PROJECT TITLE:
NEW ORAL SOLID DOSE FACILITY
Bangalore

DRAWING TITLE:
EXTERNAL AREA
SOUTH ROAD PLAN DETAIL
PART 1 of 1

PROJECT : GSK
DRAWING NO. GSK-S-CBP-EXT-ROAD-PL-01
REV. 2

DRAWING TITLE:
EXTERNAL AREA
X1 ROAD PLAN DETAIL
PART 1 of 1

ROAD PLAN

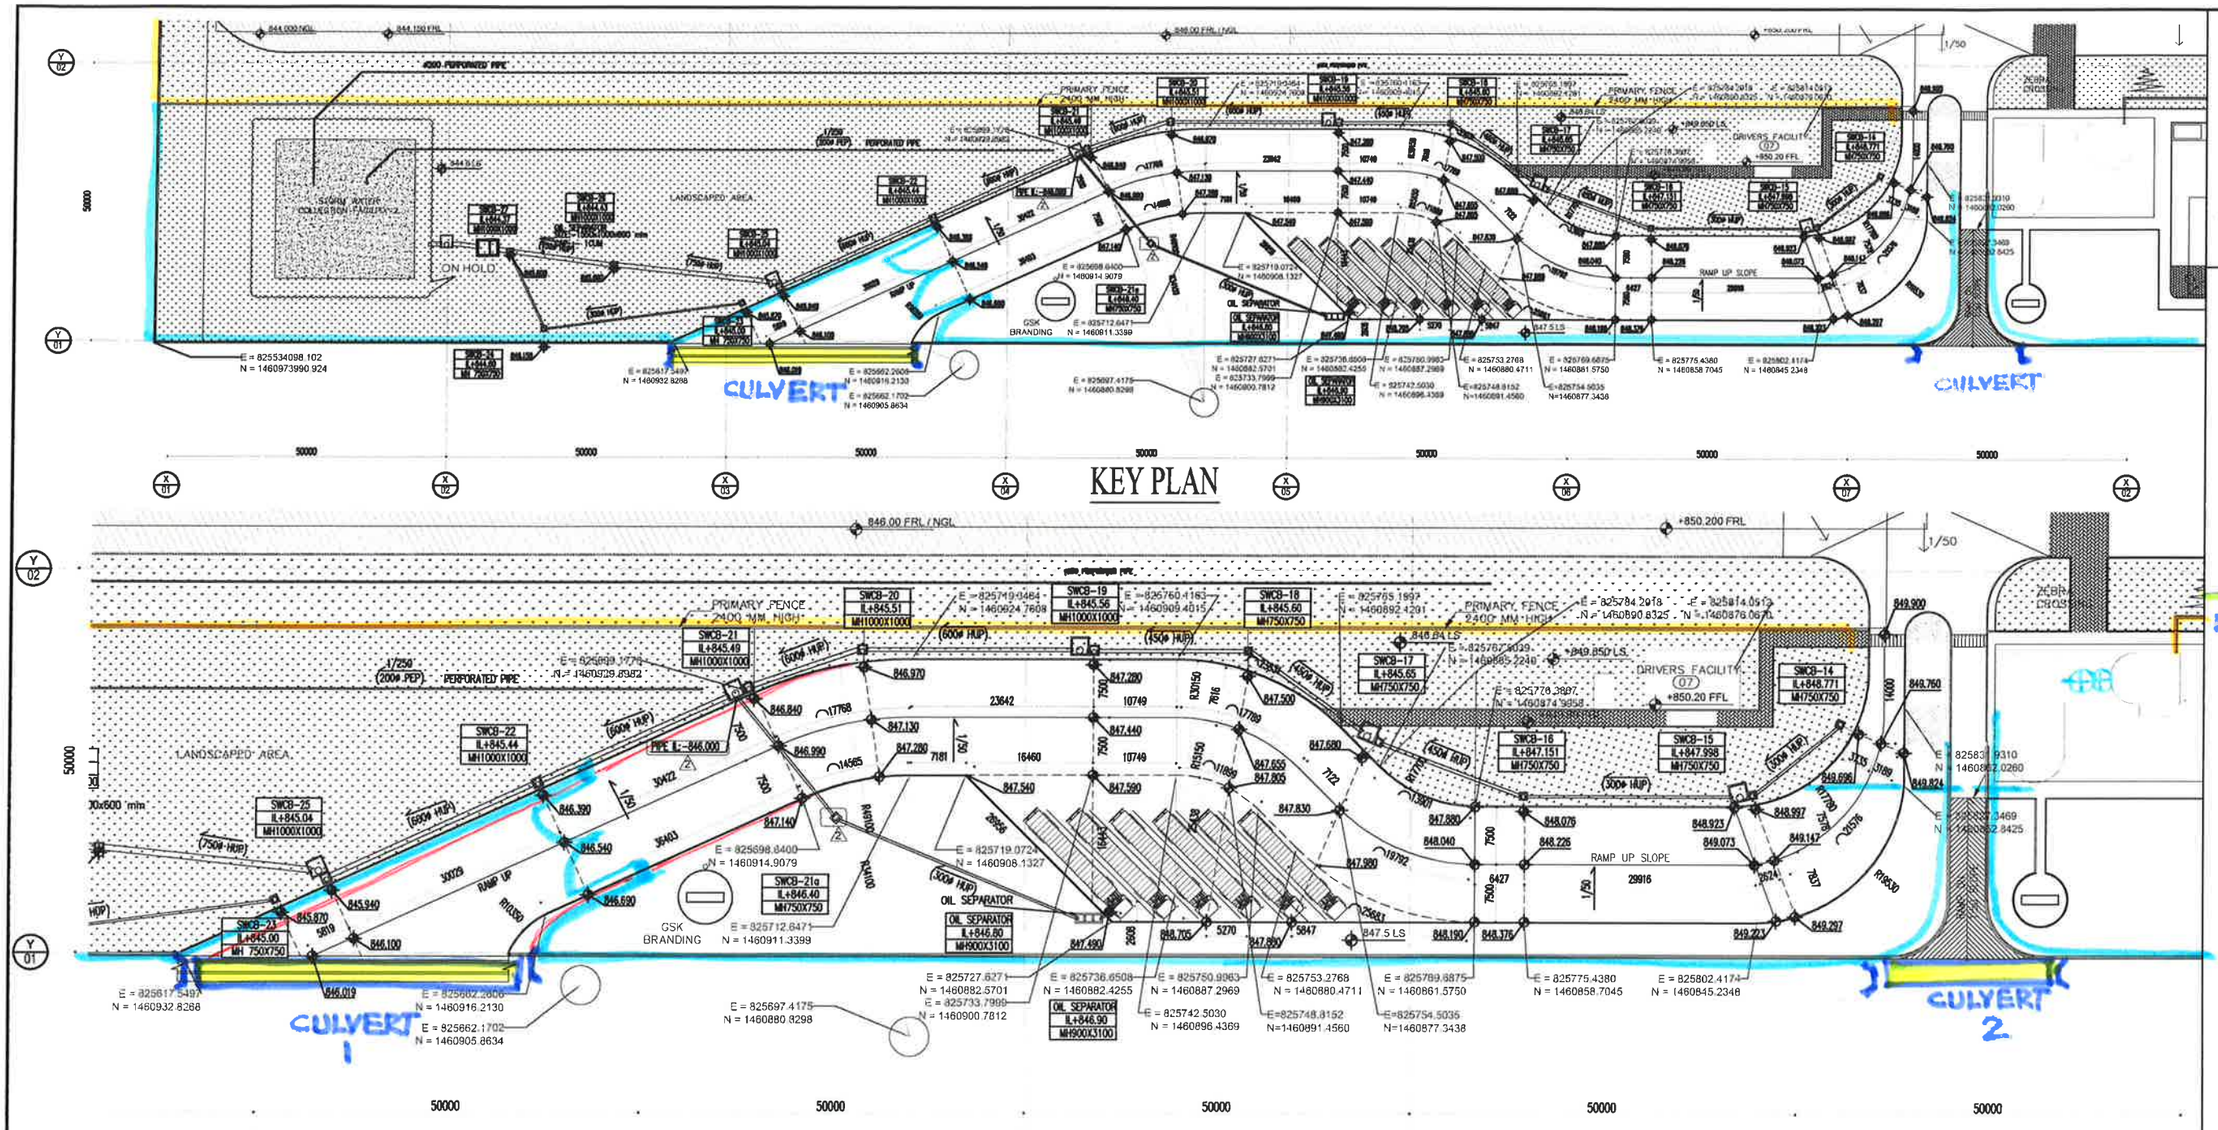
NEED TO SHIFT ROAD LINE TO ACCOMMODATE BOUNDARY FENCE & GATE COLLUMN.

CHANGES / MODIFY:

(1) 15m SWING GATE TO BE ADDED AT TRUCK ENTRY (MANUAL)
(2) BOUNDARY WALL LENGTH MODIFY – INCREASE
(3) SECONDARY FENCE GRILL HT INCREASE TO 1200 mm
(4) CULVERT ADDED TO ENTRY / EXIT GATE.
(5) ROAD TO BE ADJUSTED.

DISCUSSED WITH MR. STEVEN
07/SEP/2016

X1 ROAD PLAN

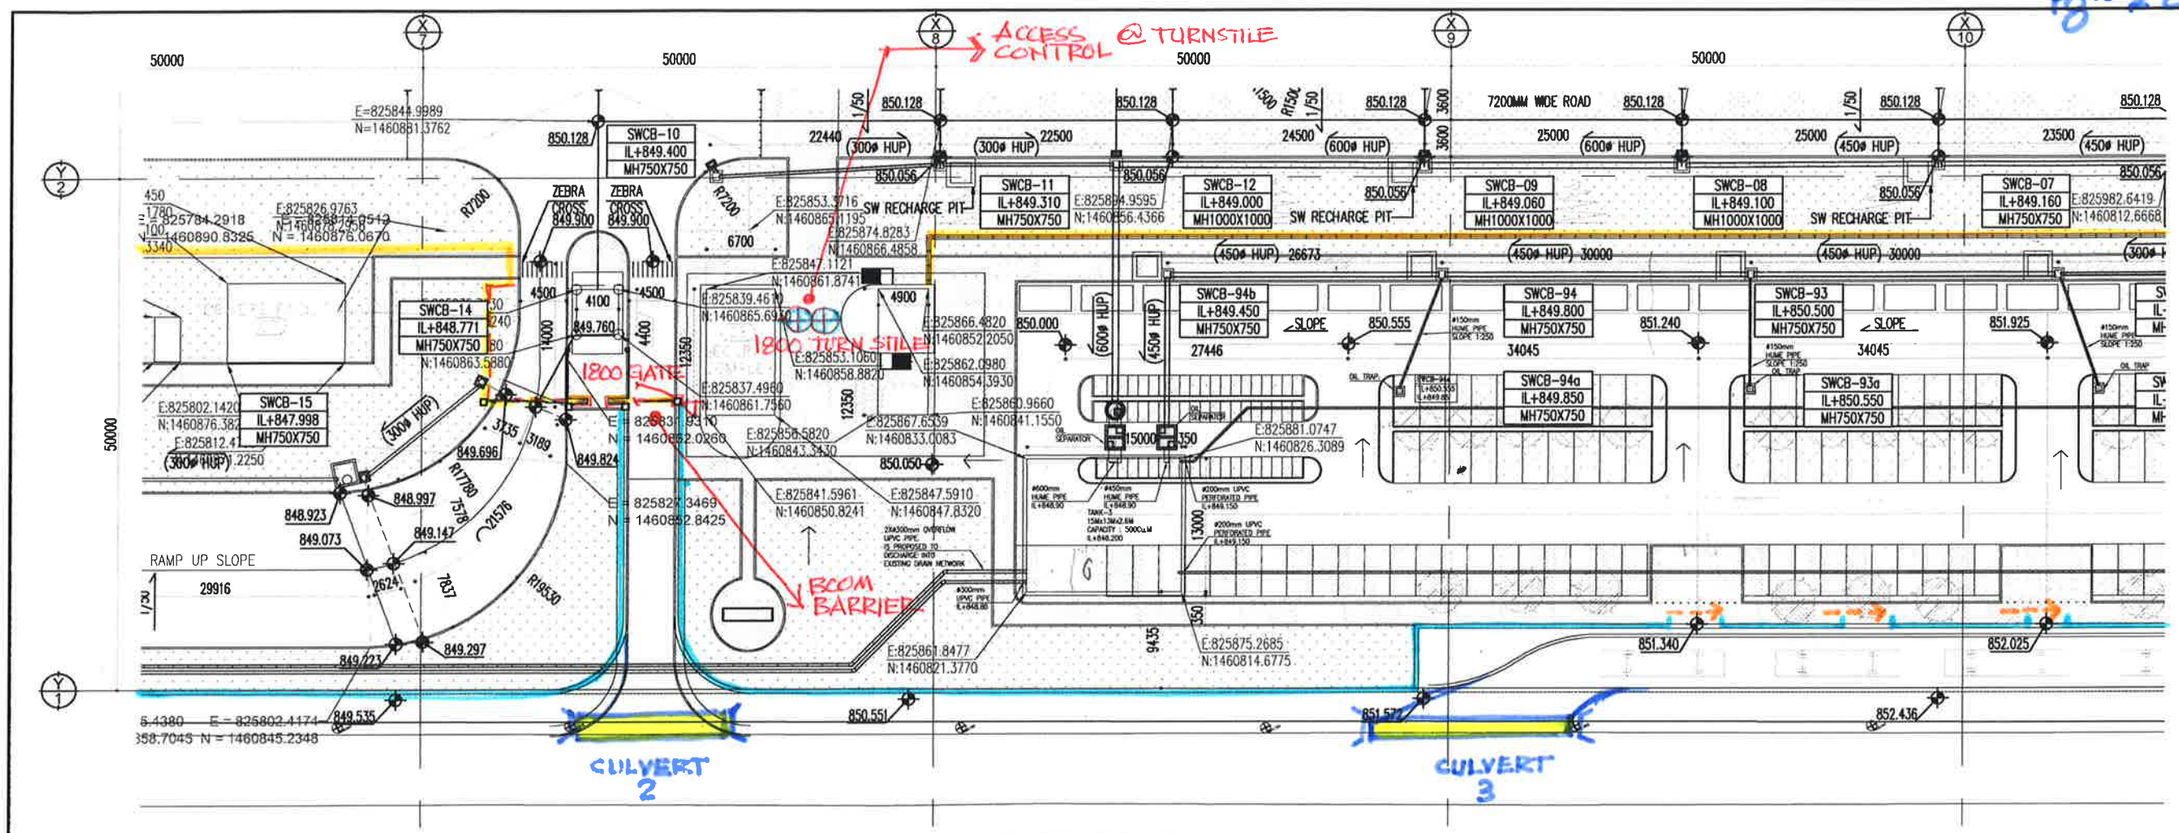
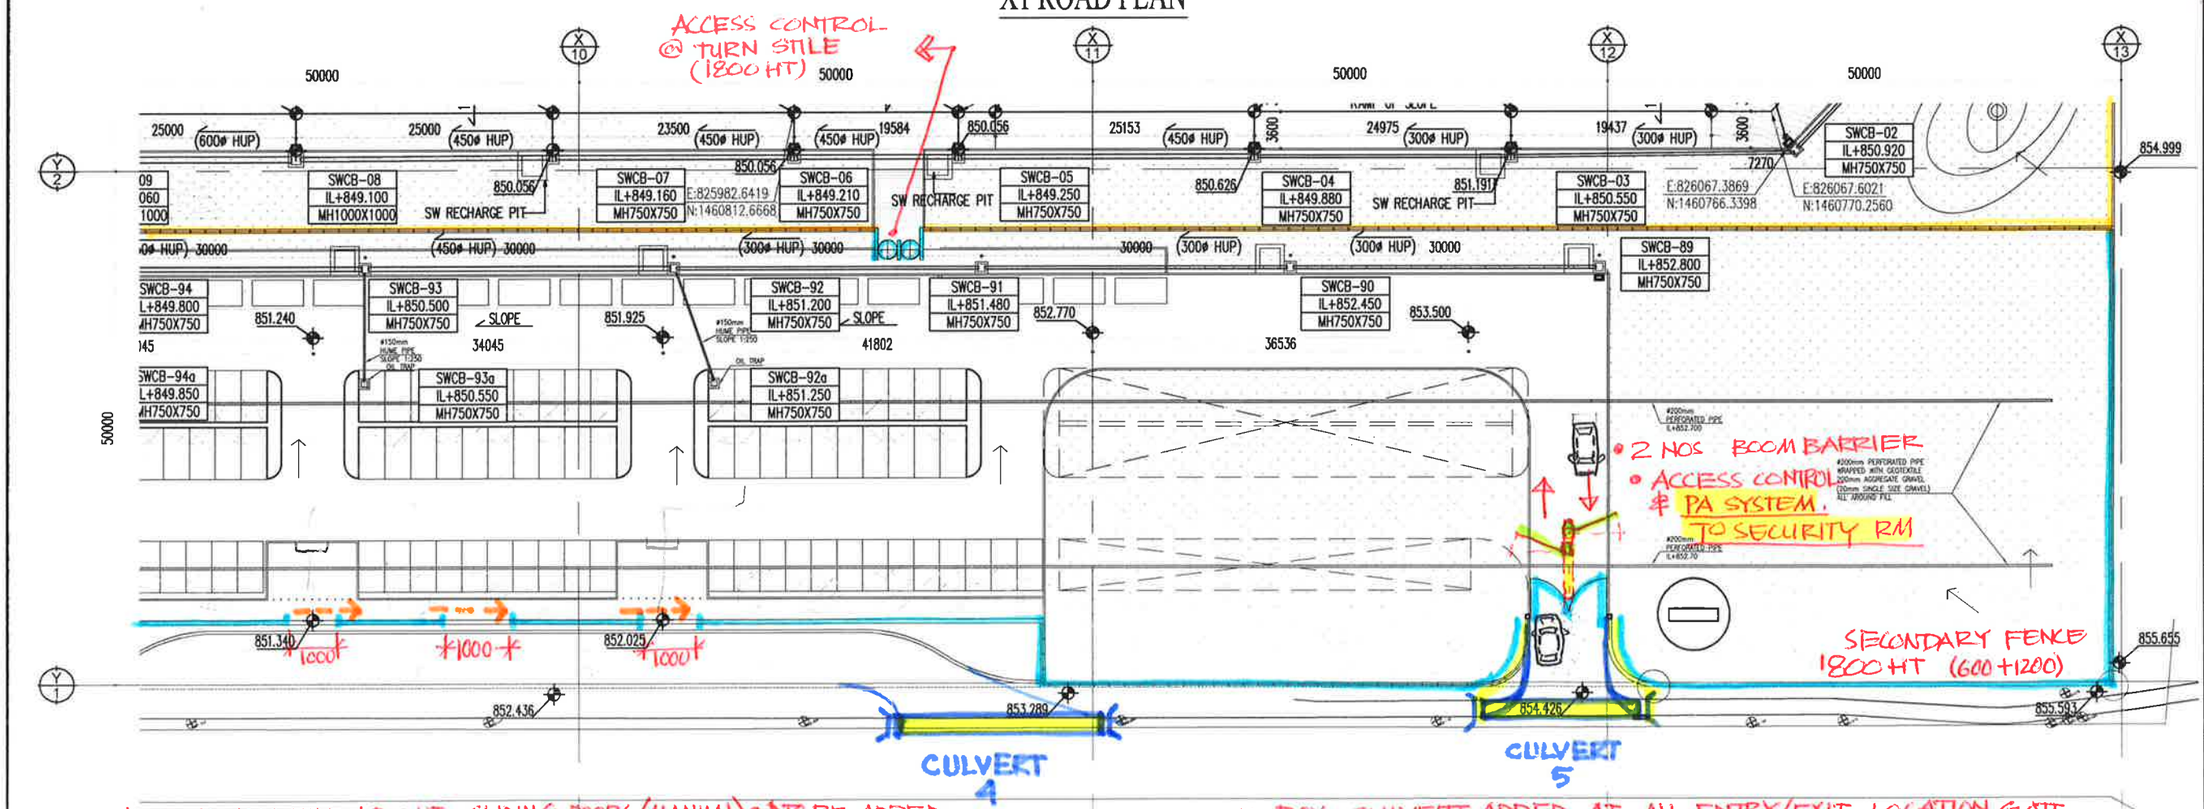
* 3 NO. 1000 WIDE 1800 HT SLIDING DOORS (MANUAL) → TO BE ADDED

* BOX CULVERT ADDED AT ALL ENTRY/EXIT LOCATION GATE WITH METAL CATTLE TRAP.

* TURNSTILES 1800HT

* SECONDARY FENCE = 1800 HT (1200 GRILL)
